HAMMAC SUBDIVISION

APPLICATION NUMBER 10 DATE February 18, 2016

REQUEST Subdivision

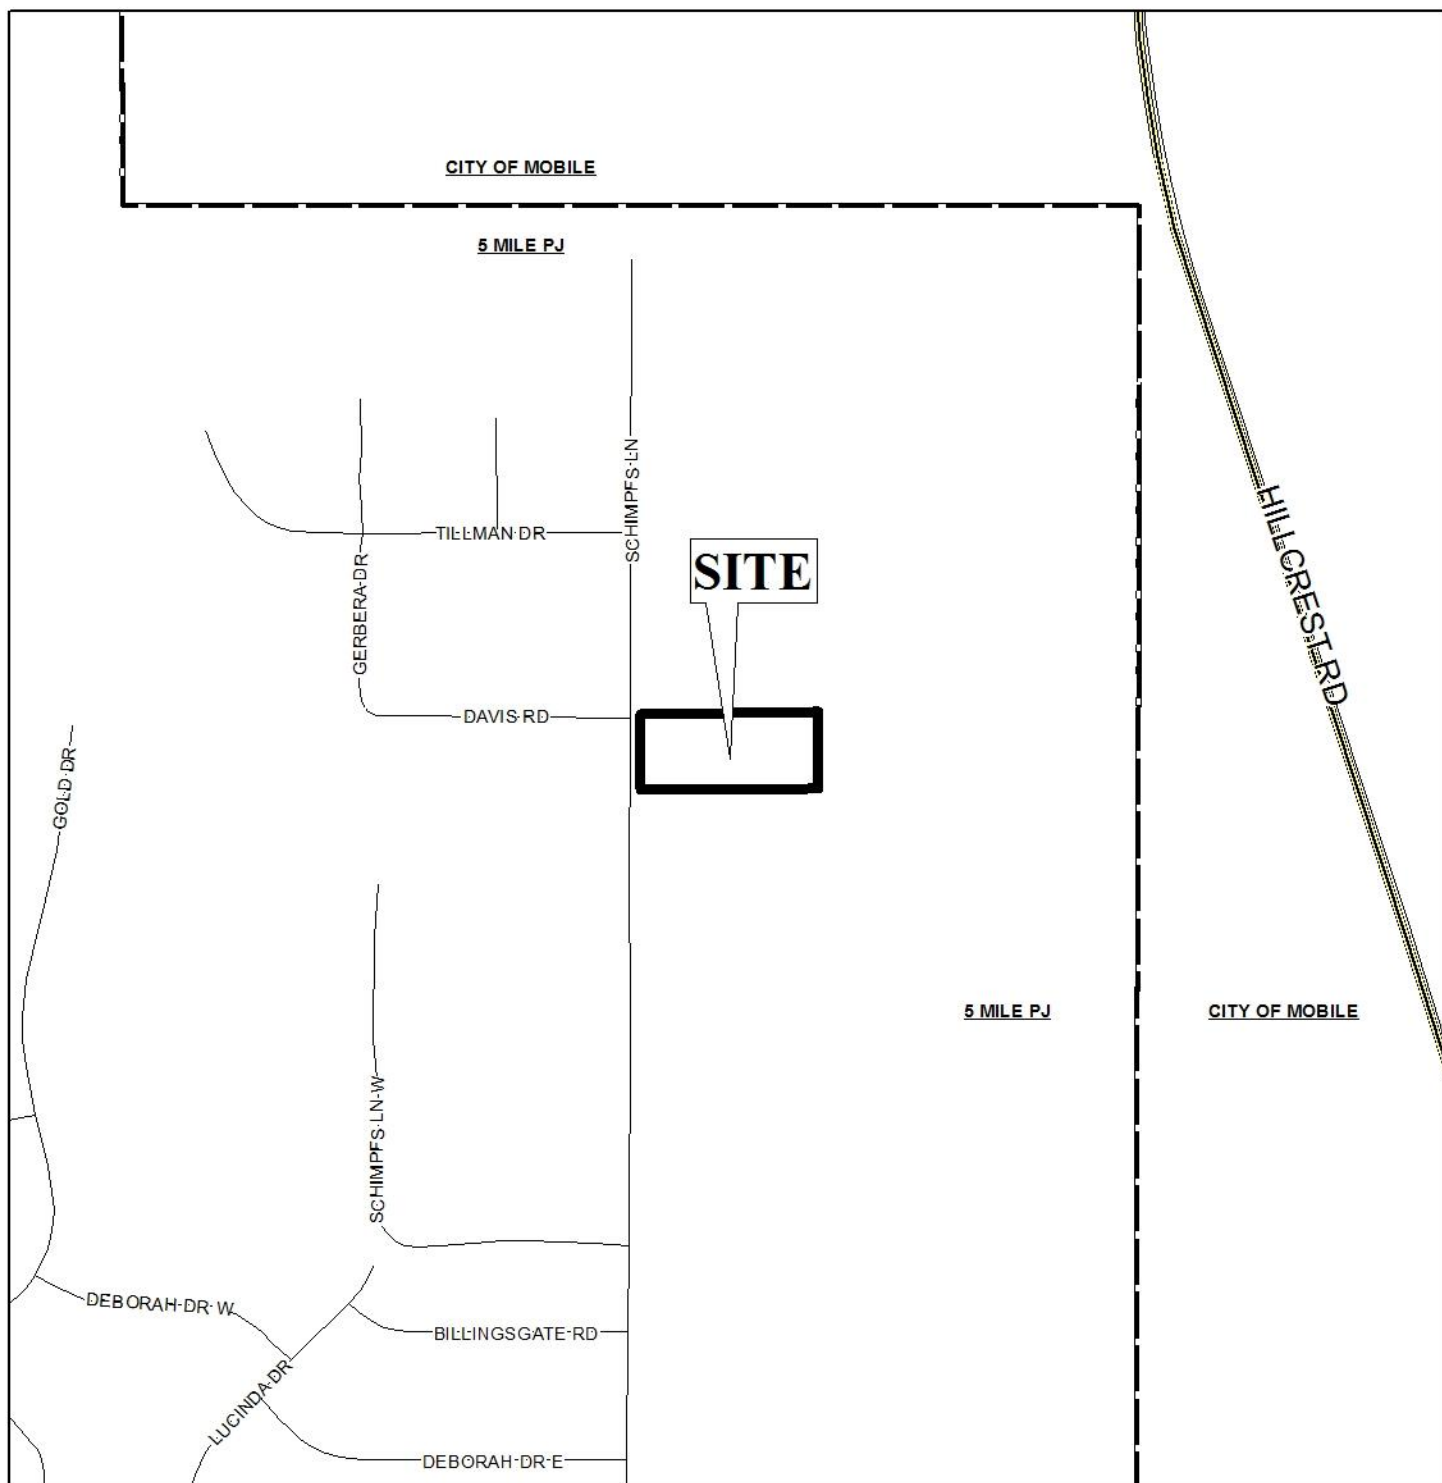
The proposed lot fronts Schimpfs Lane a paved minor street without curb and gutter. As a paved minor street without curb and gutter, this street requires a 60' wide right-of-way width. The existing right-of-way width is depicted as 50' on the preliminary plat and should be revised to reflect dedication sufficient to provide 30' from the centerline of Schimpfs Lane, if approved.

The 25-foot minimum building setback line is depicted on the preliminary plat and should be retained on the Final Plat, if approved, revised for any required right-of-way dedication.

In accordance with Section V.D.2. of the Subdivision Regulations, the proposed lot exceeds the 15,000 square foot minimum lot size requirement for lots served by public water and private sanitary sewer systems. All will still be of a compliant size after right-of-way dedication. The lot size information is depicted in both square feet and in acres on the preliminary plat and should be retained on the Final Plat, if approved.

As a means of access management, a note should be placed on the Final Plat, if approved, stating that Lot 1 is limited to the existing curb cut to Schimpfs Lane, with the size, design and location of the curb-cut to be approved by Mobile County Engineering and conform to AASHTO standards.

This site is located in the County; therefore, any lots which are developed commercially and adjoin residentially-developed property must provide a buffer, in compliance with Section V.A.8. of the Subdivision Regulations. A note should be placed on the Final Plat, if approved.

- 1) Dedication sufficient to provide 30' from the centerline of Schimpfs Lane;
- 2) Retention of the 25-foot minimum building setback line on the Final Plat adjusted for right-of-way dedication;

- 3) Retention of the lot size information in both square and in acres on the Final Plat adjusted for right-of-way dedication;
- 4) Placement of a note on the Final Plat stating that the proposed Lot 1 is limited to the existing curb cut to Schimpfs Lane, with the size, design and location of the curb-cut to be approved by Mobile County Engineering and conform to AASHTO standards;

- 5) Placement of a note on the Final Plat stating this site is located in the County, and therefore any lots which are developed commercially and adjoin residentially developed property must provide a buffer, in compliance with Section V.A.8. of the Subdivision Regulations;
